May 3rd 2013: PRODUCT STATUS NOTIFICATION – DualVee® SWI Series Wheels

Bishop-Wisecarver Corporation is informing you of the obsolescence of several components from the DualVee® Integral Studded Wheel product line.

Key differences noted below (inches/mm)

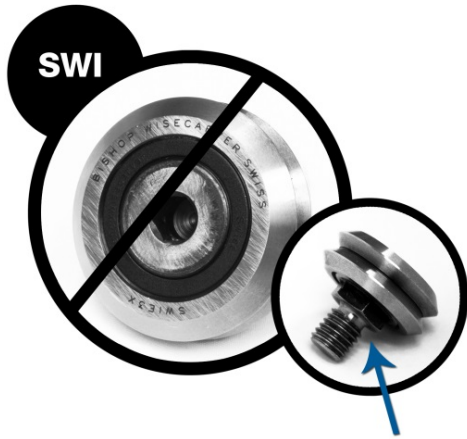
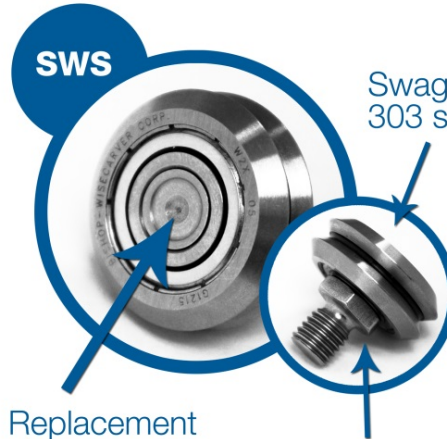
Replacement **does not** include the installation hex

Swaged stud is now 303 stainless steel

Same assembly wrench can be used
